10/645,089

David Ernest Hartley

Office Action Summary	Application No. 10/645,089	Applicant(s) HARTLEY ET AL.	
	Examiner RENE TOWA	Art Unit 3736

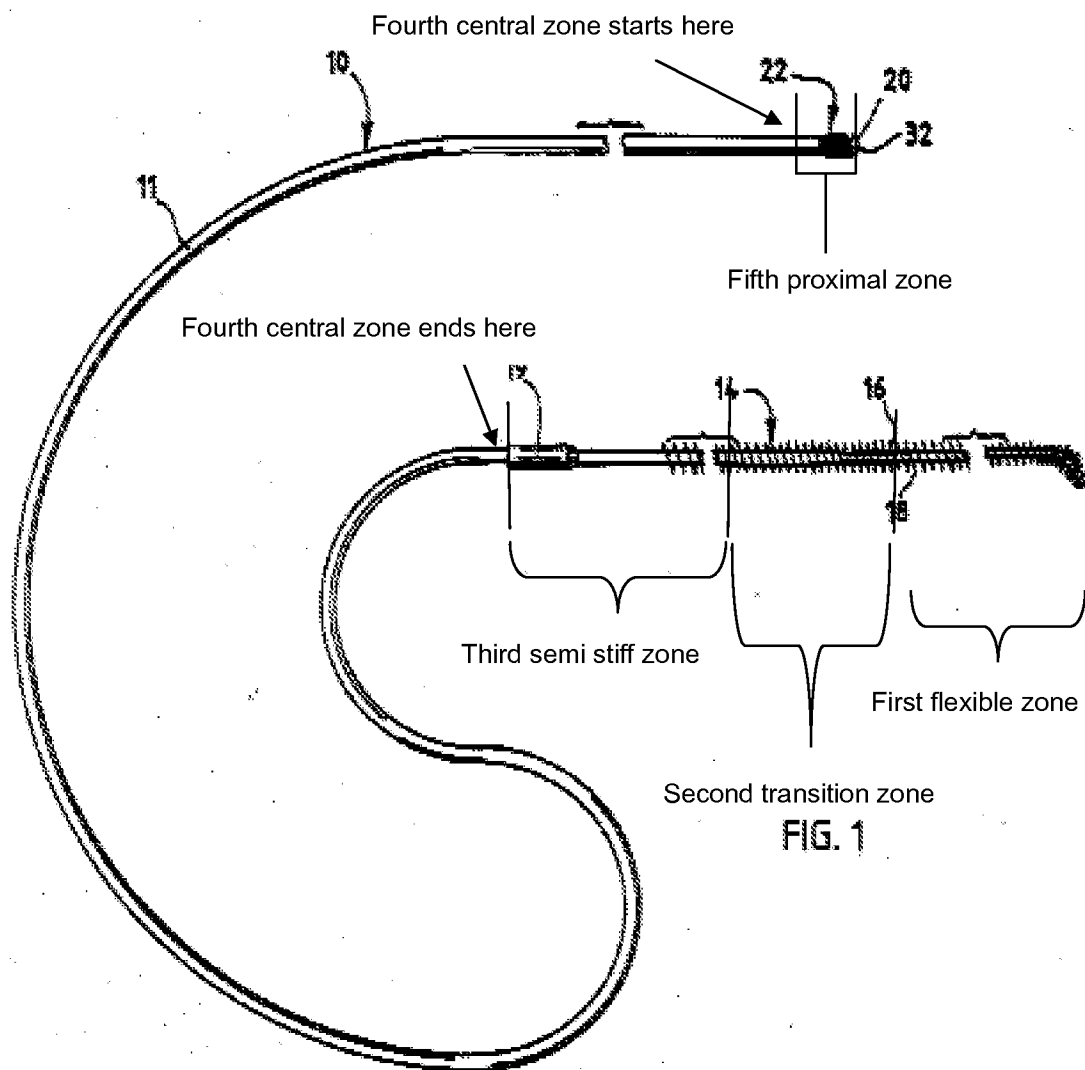
In regards to **claims 48-49, Rodriguez et al.** disclose a guide wire 10, the guide wire 10 having 5 zones of varying stiffness (see drawing below) comprising:

- (a) a proximal end and a distal end;
- (b) a fifth proximal zone adjacent the proximal end and having a semi-stiff proximal portion, a distal portion of high-stiffness, and a transition portion transitioning from the semi-stiffness of the proximal portion to the high stiffness of the distal portion, the proximal zone having a length of about 5 cm (i.e. "the proximal end tip preferably has a length of no more than about two inches") (see col. 2, lines 27-31);
- (c) a fourth elongate central zone of high stiffness adjacent the proximal zone having a substantially constant diameter along its length; and,
- (d) a distal zone adjacent to the high stiffness central zone and having a proximal portion of high-stiffness adjacent to the distal portion of the central zone and transitioning to a distal portion of highest flexibility when the distal zone comprises three zones:

(i) a third semi stiff zone having a proximal portion of high stiffness adjacent to the distal portion of the central zone transitioning to a distal portion of semi-stiffness;

(ii) a second transition zone having a semi-stiff proximal portion adjacent to the distal portion of the semi-stiff zone transitioning to a flexible distal portion; and,

(iii) a first flexible zone adjacent to the distal end and having a flexible proximal portion adjacent to the distal portion of the transition zone transitioning to a distal portion of at least stiffness and highest flexibility;

wherein the proximal zone comprises a proximal wire coil 30 of substantially constant diameter and the distal zone comprises a distal wire coil 18 of substantially constant diameter (see figs. 1-2; col. 2, lines 19-20, 27-31, 42-44 & 66-68; col. 3, lines 26-29 & 41-44; see claims 1 & 4 of Rodriguez);

wherein the first distal zone includes a distal tip pre-formed curve having a single direction of curvature having the highest flexibility (see fig. 1; col. 3, lines 7-8).
